**Players Please / Dublin 8 Residents**  
**Playersplease.com**

# **Bailey Gibson 2**

**Planning Ref 314171**

**Subject: 314171: Former Bailey Gibson Site, 326-328 South Circular Road. Rehoboth Place, Rehoboth Avenue, South Circular Road and Donore Avenue, Dublin 8. ([www.bgscr1shd2.ie](http://www.bgscr1shd2.ie)).**

Fig. W from DCC Development Plan 2016-2022 Housing Strategy Appendix 2A

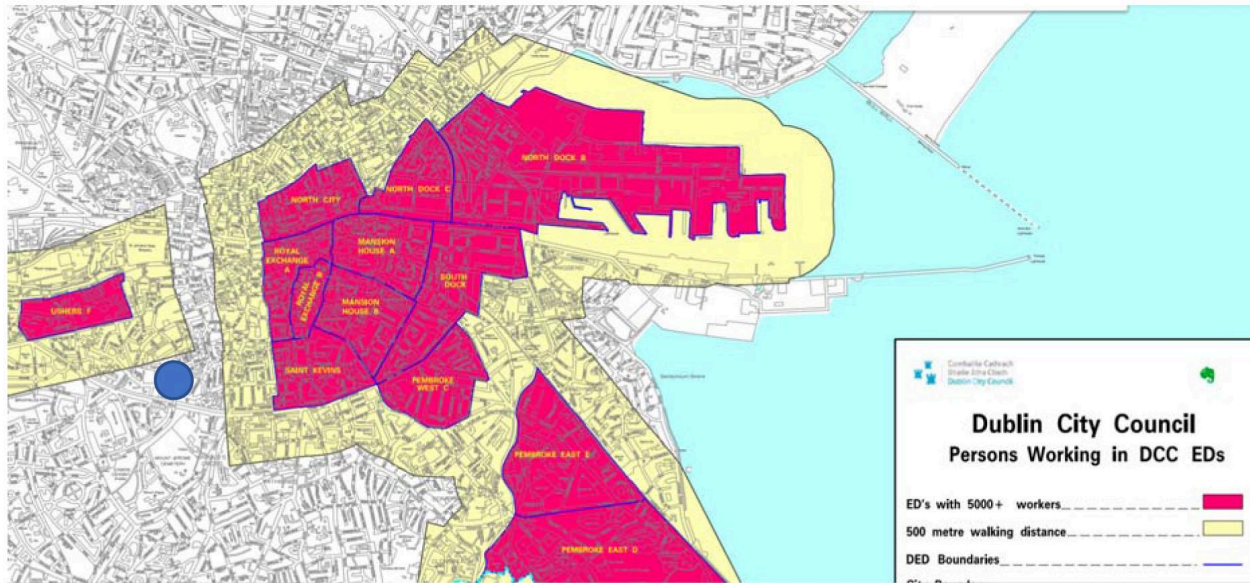
Development on a site within 500m of an employment centre may increase that limit to 42-50%. The Material Contravention Statement notes that the site falls outside of an area within 500m of an employment centre, as shown on the figure below, and as such the higher limit does not apply.

As the residential units on this site do not lie within 500m of an employment centre, the unit breakdown should be as per DCC Residential Quality Standards, which states:
